U. S. NUCLEAR REGULATORY COMMISSION

Report No. 50-312/85-16

Facility Name: Rancho Seco Unit 1

Inspection between June 1-July 14 and July 20-31, 1985 (Report No. 50-312/85-16)

FIGURE 1

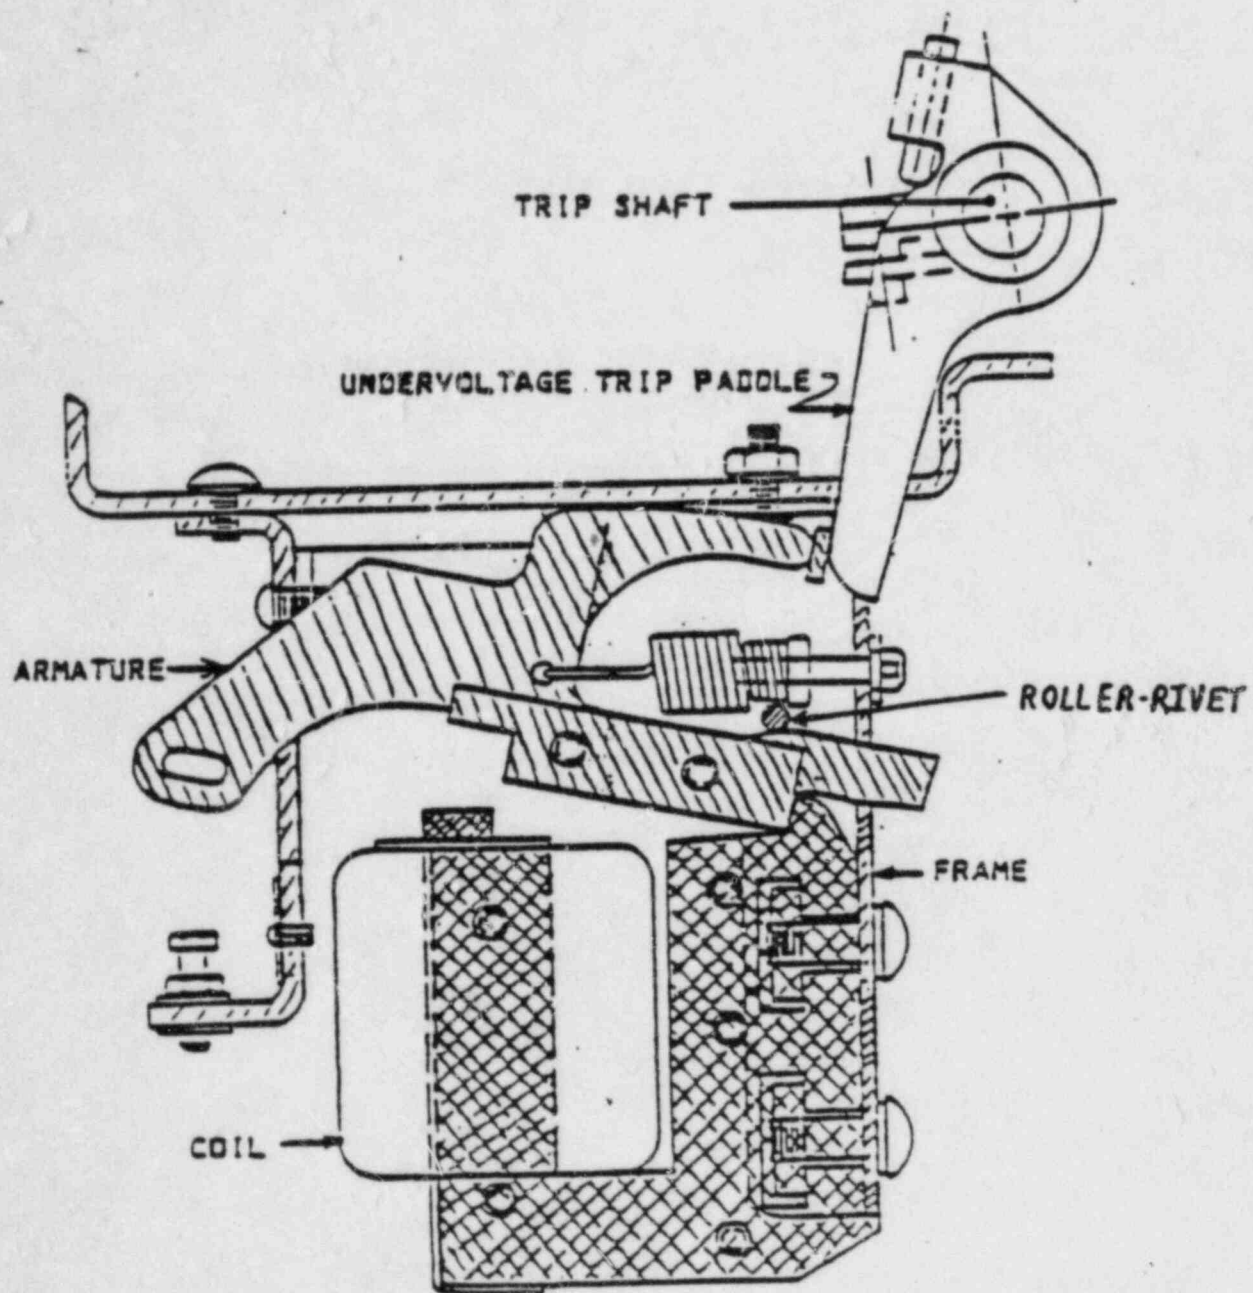
On June 5, 1985, while the licensee was performing surveillance and calibration on the "C" channel of the Reactor Protection System (RPS), the reactor trip breaker (RTB), see Figure 1, failed to trip open when its undervoltage trip attachment (UVTA) was actuated. The licensee stopped the test being performed, and observed that the undervoltage (UV)

On June 6, 1985 the inspectors observed a bench check of the RTB that failed. The licensee was able to trip the breaker several times using the UVTA; but it was noted that the trip paddle (see figure 1) appeared to be loose. The licensee was able to move the trip paddle over the armature and prevent the armature from moving out of the energized position. This configuration appeared to have simulated the original failed condition of June 5, 1985, because the armature, could not engage the trip paddle when the UVTA was deenergized. However, the shunt trip was able to trip the breaker. The licensee then rotated the trip paddle to its proper position and was able to trip the breaker using the UVTA.

appeared to be an excessive armature to rivet gap clearance. The armature to rivet gap was determined to be approximately .059 inches. The specification range was .001 to .010 inches. The greater armature to rivet gap has been shown to allow the trip paddle to move freely and possibly interfere with the proper operation of the armature.

It appears to date that the excessive armature to rivet gap could have been caused by vibrations of the breaker during transportation to and from the GE and B&W facilities.

The licensee identified that the GE Service Bulletin recommended the measurement of the armature to rivet gap, but did not specify the proper position of the armature when measured. The licensee discovered that GE technicians always measured this gap with the armature in the energized position.

The licensee has incorporated the guidance of the GE Service Bulletin into their surveillance procedure for the RTBs. Additionally it appears that the failure mechanism, excessive armature to rivet gap, has been appropriately identified and the corrective actions performed satisfactorily tested all RTBs before the licensee began withdrawing control rods.
